6491 Calle Real Mixed-Use

PLANNING COMMISSION
REQUEST FOR DISCRETIONARY APPROVALS
SEPTEMBER 11, 2023

Proposed Project 7/25/23 DRB:

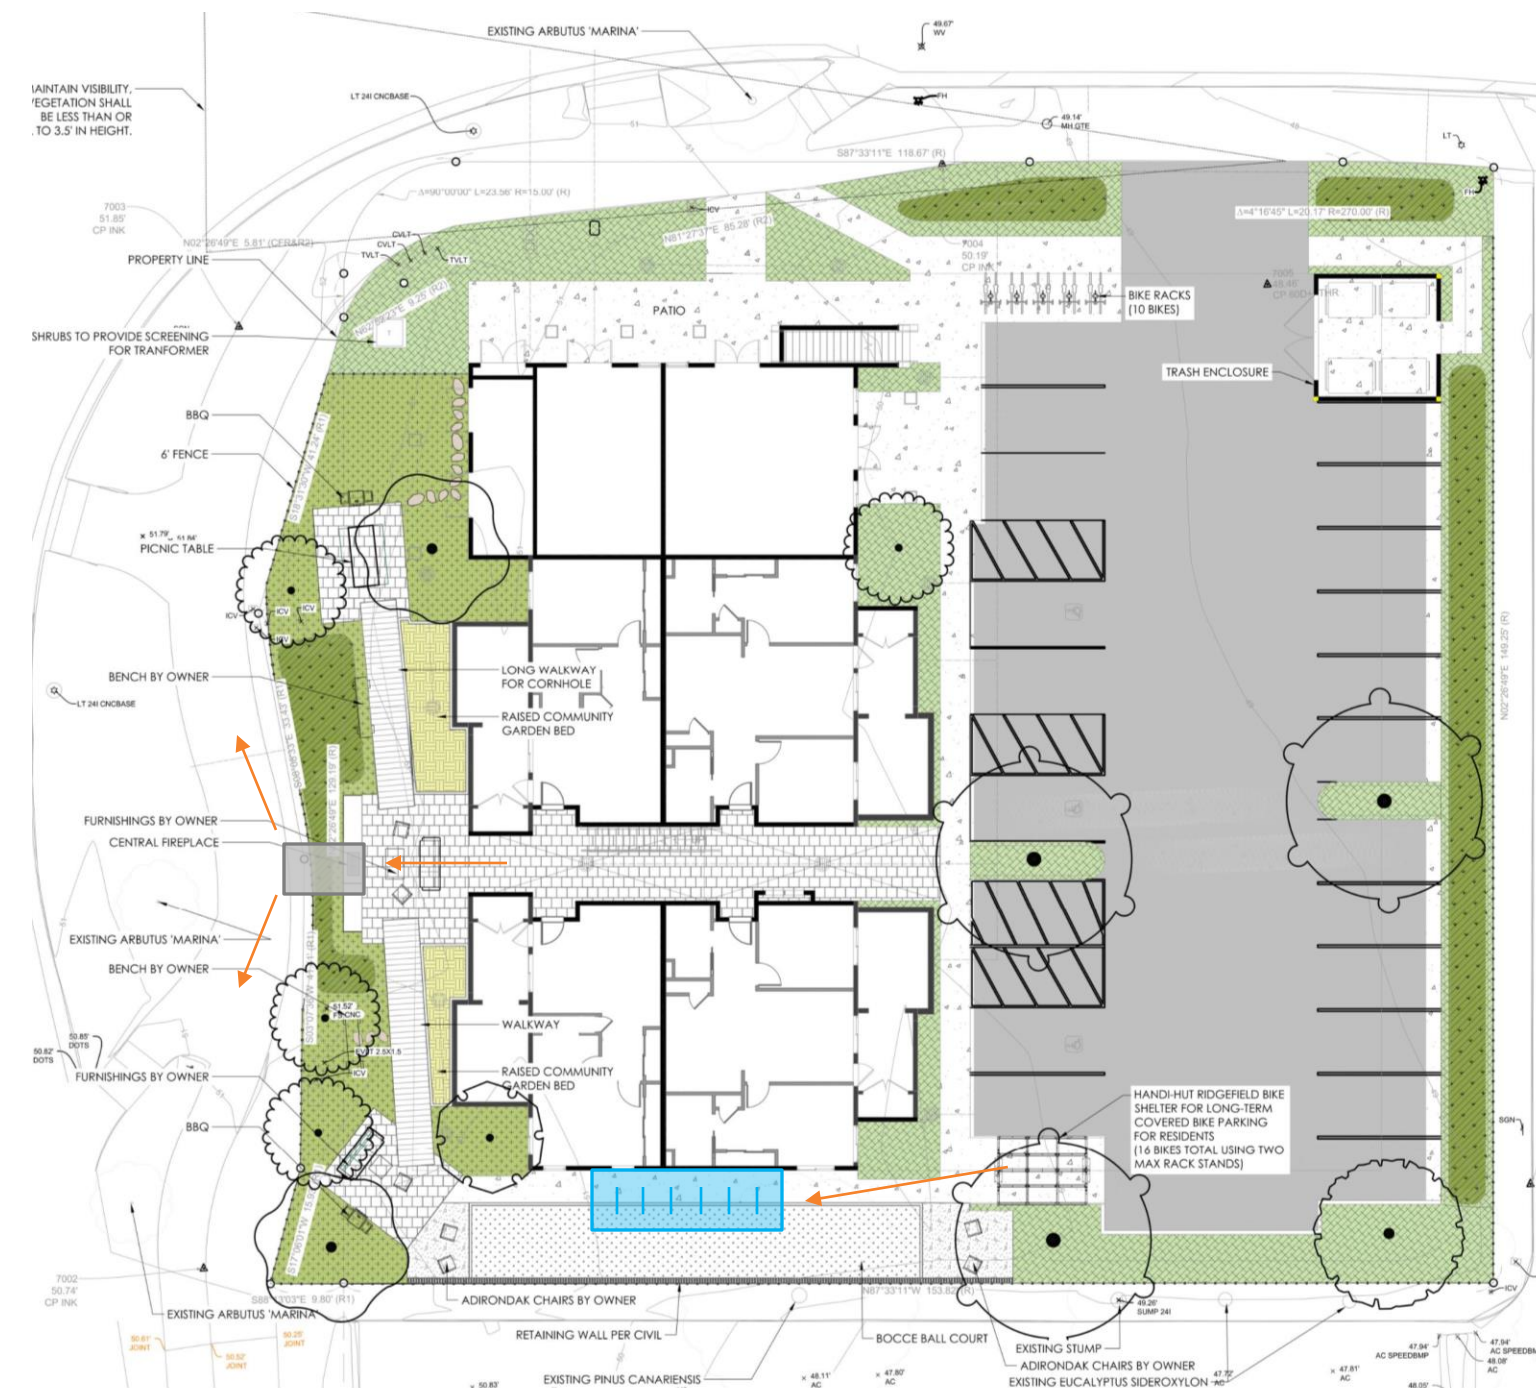
- ✓ Reconsider color palette
- ✓ Restudy pitched roofs
- ✓ Downspouts should be better integrated with building and painted to match wall color

- ✓ Study South elevation
- ✓ Consider removing bocce ball court and moving bike parking to south of building, and options for an access gate near southwest corner
- ✓ Better integrate bike storage

1. Study relocating or screening infrastructure items at northwest corner of the site
2. Study better integrating stair on north elevation with building
3. Revisit stormwater connection
4. Reconsider specific plant selections, refer to comments in DRB video

Potential Revised Elevation in response to DRB conditions:

Other Comments to be addressed with DRB at Final Approval:
